ADDENDUM NO. 1 TO PROJECT NO. 44254

**PROVIDE SECURITY WINDOWS
ADMINISTRATION BLDG NO. 24 AND HOUSING BLDG. NO 7
ALBION CORRECTIONAL FACILITY
3596 STATE SCHOOL ROAD
ALBION, NEW YORK 14411**

February 8, 2013

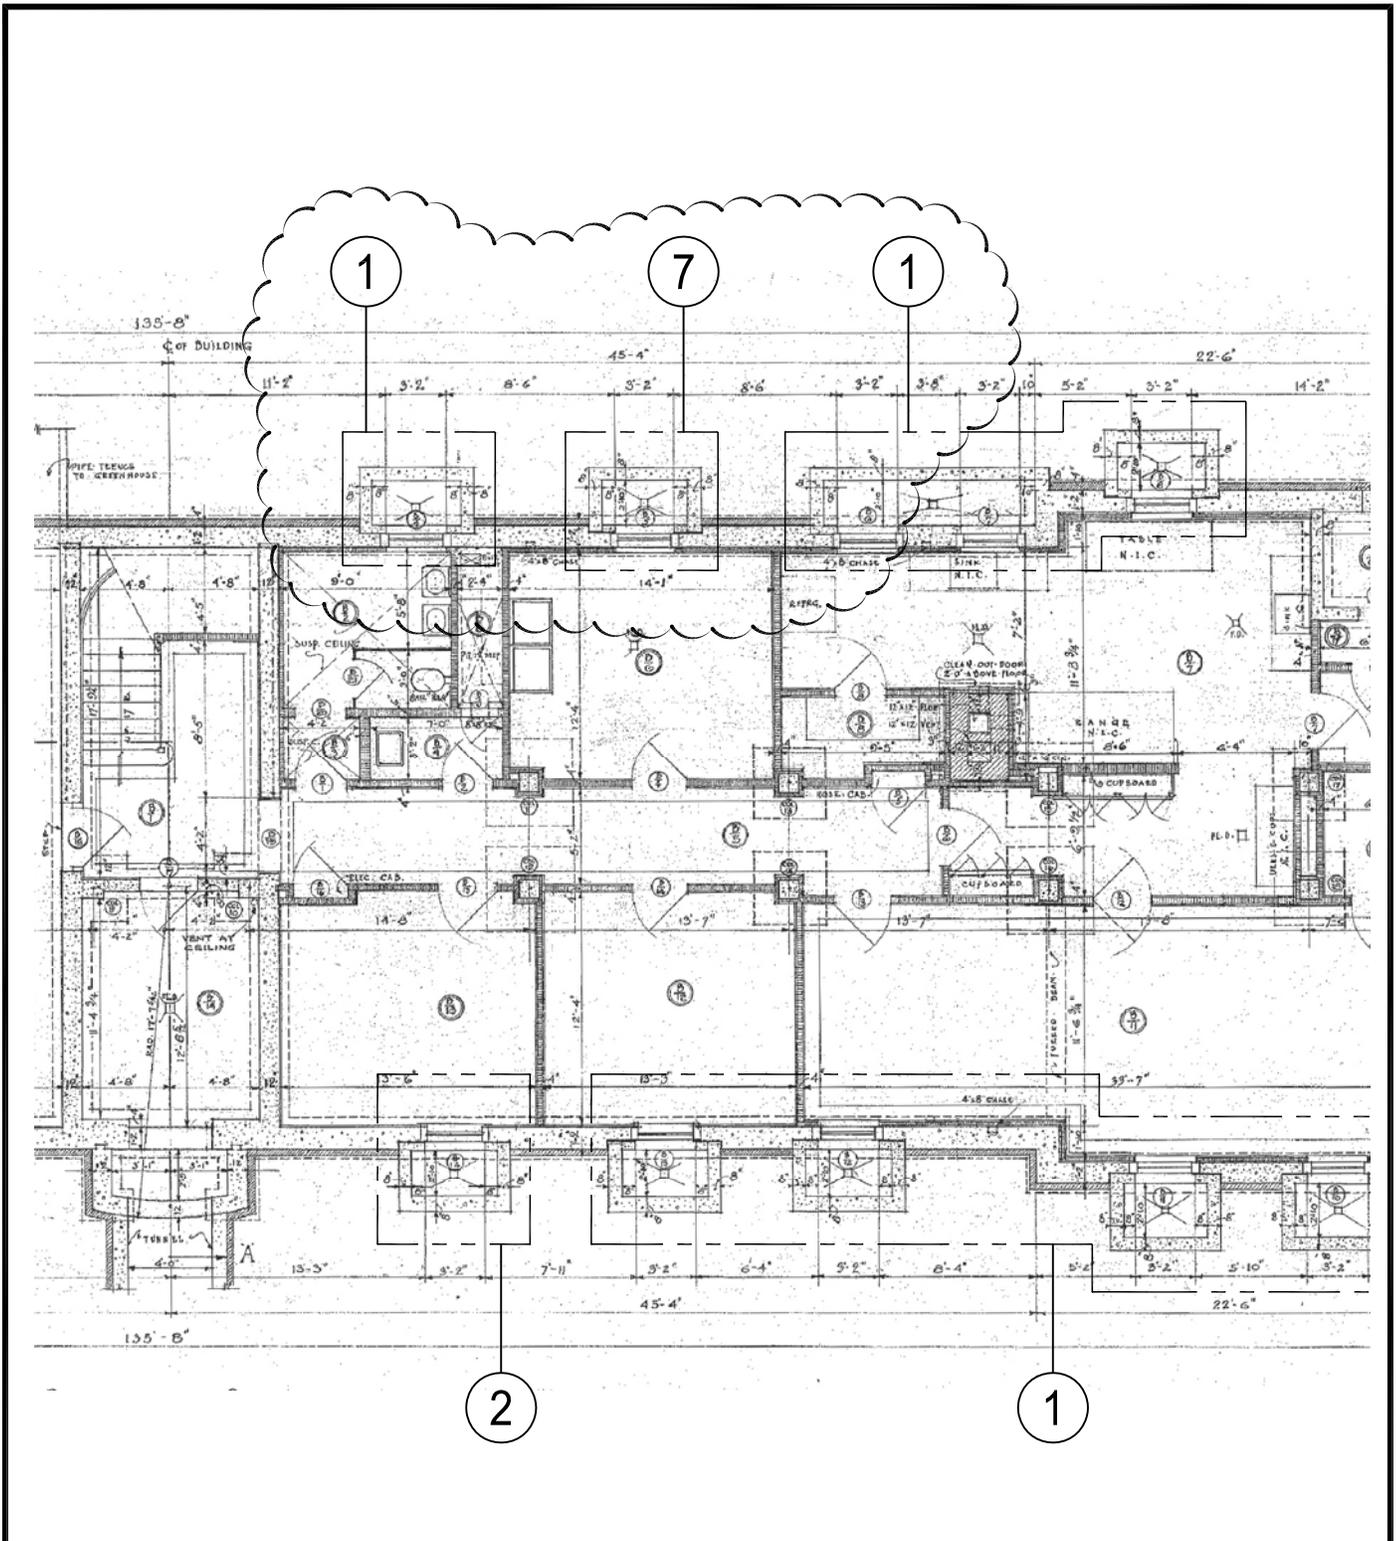
1. Drawing No. A101:
 - a. **Modify** plan 3/A101 per attached drawing ADD1-SK-A1
 - b. **Modify** General Removal Notes, per attached drawing ADD1-SK-A2
2. Drawing No. A702:
 - a. **ADD** detail 4/A702 per attached drawing ADD1-SK-A3
 - b. **ADD** detail 5/A702 per attached drawing ADD1-SK-A4

DWG NO:
ADD-01-SK-A2

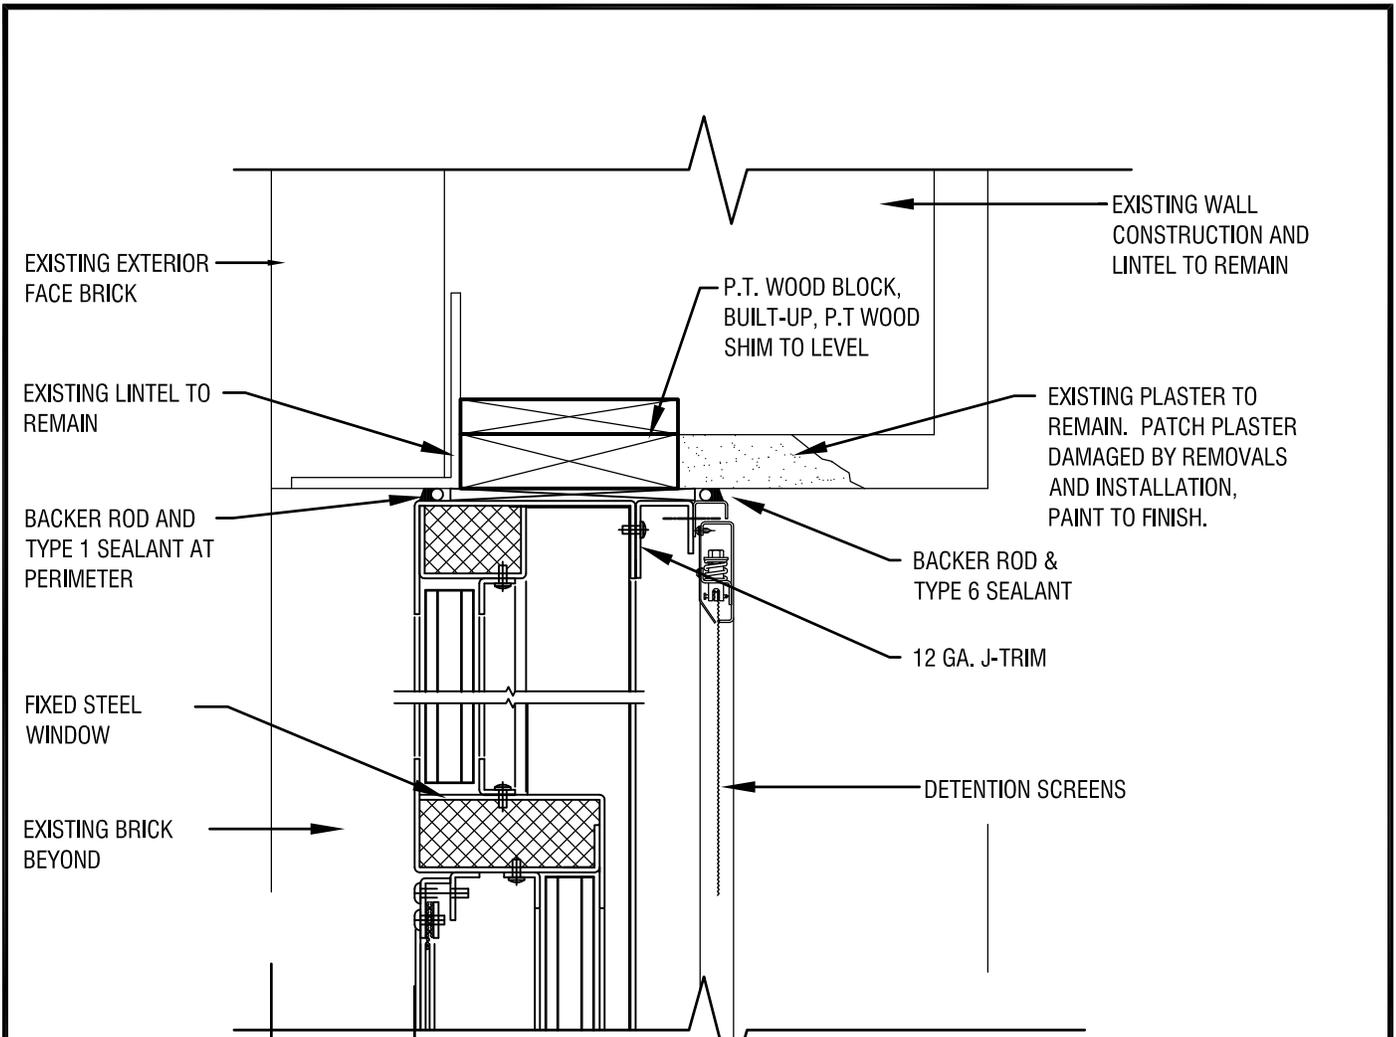
7. REMOVE EXISTING EXTERIOR STEEL DETENTION SCREENS, HARDWARE AND ANCHORS AT EXTERIOR. REMOVE EXISTING WOOD WINDOWS, INCLUDING BLOCKING, TRIM AND ASSOCIATED HARDWARE. SEE WINDOW REMOVAL DETAILS ON SHEET A701. PRIOR TO REMOVALS, CORE HOLE THROUGH EXISTING EXTERIOR MASONRY WALL AS REQUIRED FOR RELOCATION OF EXISTING DRYER VENTS (2 TOTAL) TO SIDE OF EXISTING WINDOW. DISCONNECT EXISTING DRYER DUCTS AND PROVIDE HOOK UP TO RELOCATED LOCATION. PROVIDE DRYER DUCT AND EXTERIOR WALL CAP.

SHEET TITLE:
GENERAL REMOVAL NOTES: (ADD KEY NOTE 7)
